CRAIG WEBB
Consultant Arborist

ARBORICULTURAL MEMO

Date: 2 September 2025
To: David Hay – Osborne Hay Limited
From: Craig Webb
Subject: **Arboricultural impact assessment for a proposed community housing development at 1695 Pohuehue Road, Warkworth**

Figure 1 –The location of 13 surveyed trees at 1685 Pohuehue Road on an aerial photograph (Auckland Council GeoMaps)

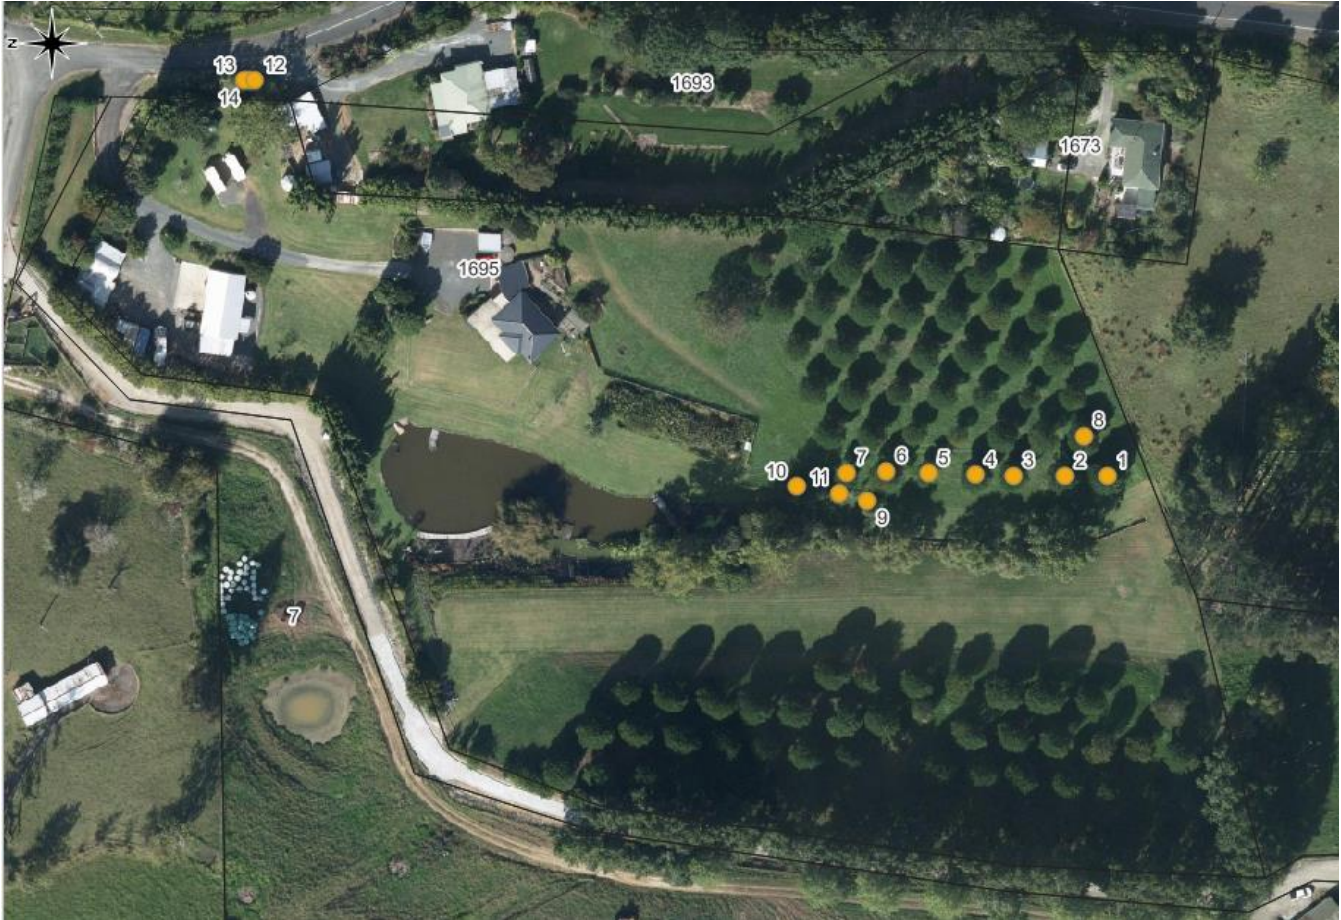
13. *Notwithstanding question 12, seven pine trees are proposed to be removed within the riparian margin of a rural stream, which provide habitat, shading and facilitate water infiltration within the riparian margin. There is limited information regarding the stature of these seven pine trees and their alteration and removal requires resource consent under the rules within chapter E15 of the AUP(OP) as restricted discretionary activity as has been applied for. Please address this including the provision of an arboricultural assessment that address the criteria listed in E15.8 of the AUP(OP) and provides further information (such as tree height, maturity, canopy coverage etc.) to justify that the loss of the subject pine trees will be acceptable with respect to their function within the riparian margin of the subject rural stream.*

14. *As these pine trees provide ecosystem functions within the riparian margin, please demonstrate that their loss will be adequately mitigated. A replanting proposal within the riparian margin with native trees would likely be considered appropriate.*

15. *It is noted in the submitted AEE that the removal of three street trees (pittosporums) on Valerie Close (to form the new driveway into the site) is proposed. Please provide more detail in respect of the size of these trees to demonstrate that their removal is a permitted activity under Chapter E17 of the AUP(OP). Please note that removal of street trees over 4m high or greater than 400mm in girth requires resource consent under Rule E17.4.1(A10) of the AUP(OP) as a restricted discretionary activity.*

Seven stone pine trees are within 20 m of the stormwater channel. These trees are not of substantial height or crown spread, such that their provision of shade to the waterway and habitat values is negligible.

More importantly, the 20 m margin of the stream contains various trees, including trees 9-11, that do provide shade and ecosystem services values. In particular, two kahikatea trees are positioned in their ideal habitat and will thrive in this location in the margin of a stream. These trees, along with other vegetation growing on the stream bank must be protected from harm during site development works. To this end, I recommend that a tree protection fence is erected as shown on the tree protection plan appended to this memo.

Within the road reserve of Valerie Close, outside the frontage of the property is a row of tarata, or lemonwood (*Pittosporum eugenoides*) The group contains dead trees and trees that are in poor condition. Several of the trees, including dead trees and Trees 11, 12 and 13 require removal to establish an entrance to the development site. Due to the poor condition of the trees, their removal results in negligible impacts on tree canopy cover.

In conclusion, removal of trees within 20 m of the stormwater channel is limited to seven stone pine. Native trees that provide habitat and shading within the riparian margin should be retained and protected.

The pine trees to be removed do not provide ecosystem functions within the riparian margin, so their loss requires no mitigation. Retaining and protecting native trees within 20 metres of the stream and all stream side trees is adequate mitigation in my opinion.

The removal of three street trees on Valerie Close will result in negligible impacts in terms of tree canopy cover loss. The removal of trees in roads over 4 m in height requires resource consent as a restricted discretionary activity.
